PCB-640

SPORT

Increased tank dimensions and capacity for the standard tanks.

Tank Line Profile

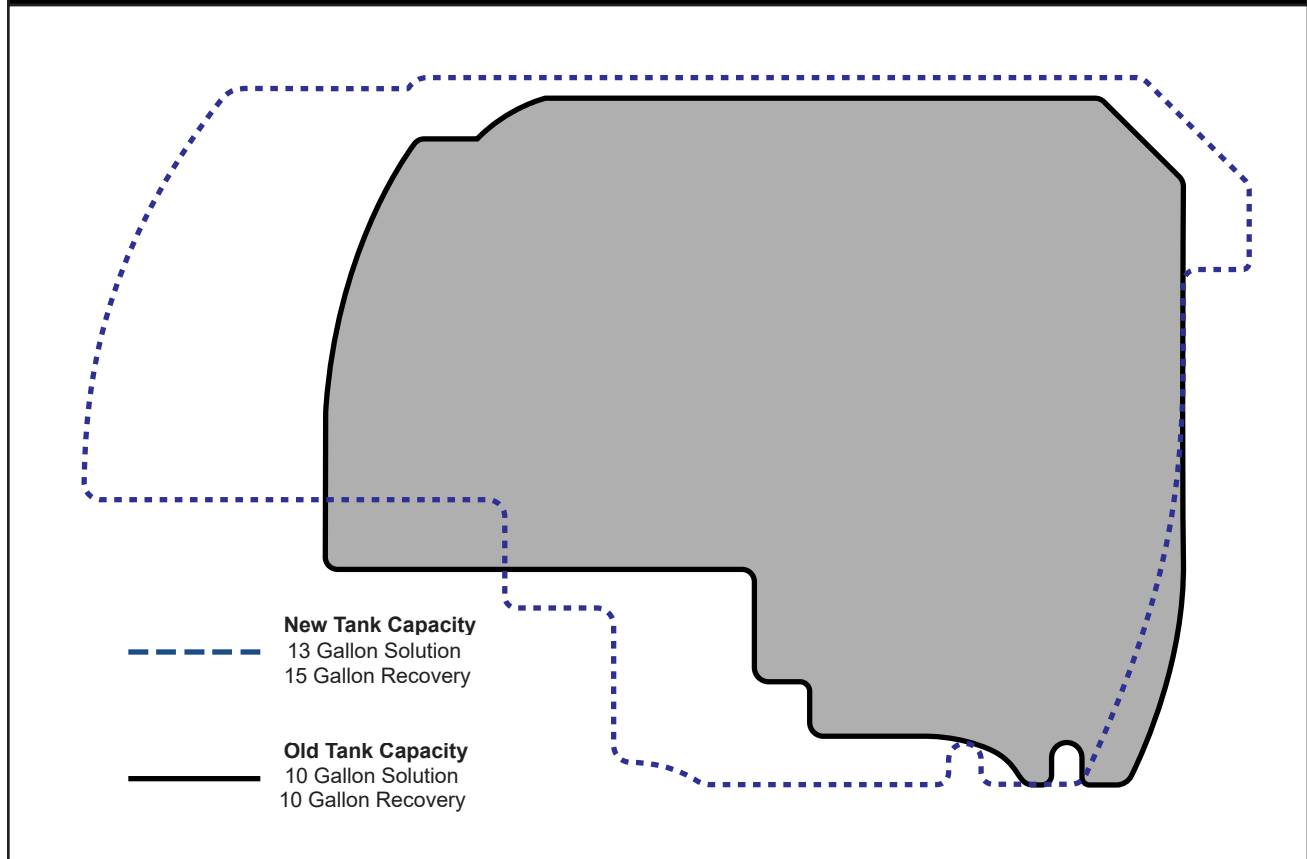
Old machines with 10g Sol./10g Rec. tanks cannot be equipped with new 13g Sol./15g Rec. tanks.

Increased tank dimensions and capacity for the standard tanks to more easily qualify which machine an End-user should purchase and bring popular features from larger CARBON/HERO down to the smaller SPORT.

Bandeau & Suds Reservoir:

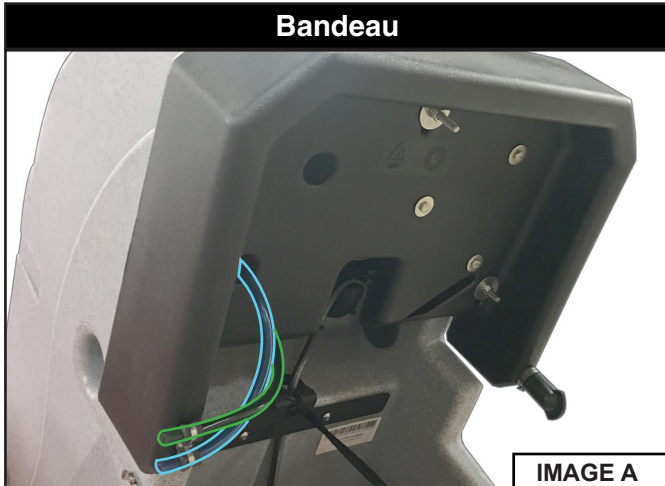
Added Vacuum Bandeau System (identical to the CARBON/HERO) to the tanks to protect the Vacuum Motor as well as reduce dB levels of the machine. Bandeau System includes blue drain hose (Image A) for moisture that potentially gets past the vacuum motor. New added space for Suds reservoir (Image B). Green Hose (Image A) included on all SPORTS for Suds reservoir draining.

Baffle Assembly:

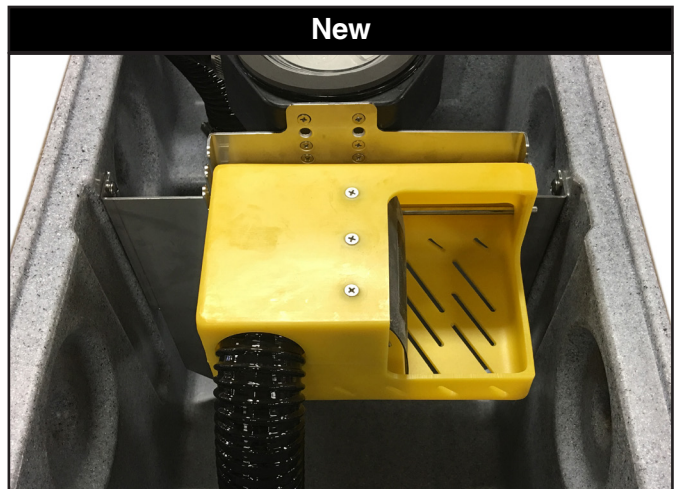
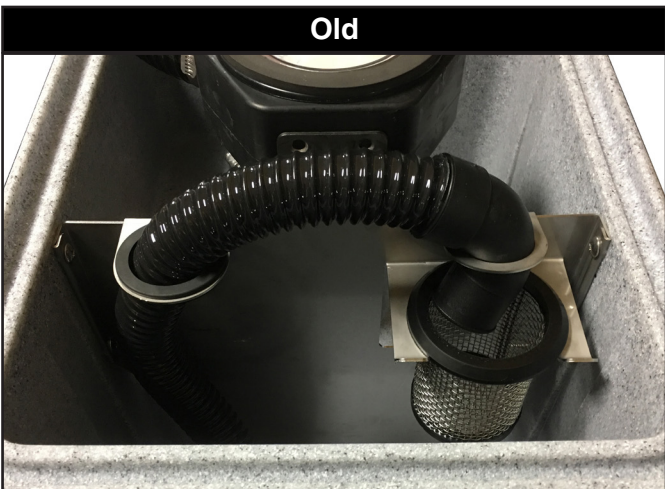
Added enlarged Drain Saver Basket like the CARBON/HERO. Yellow drain saver baskets will be standard after August 1st.
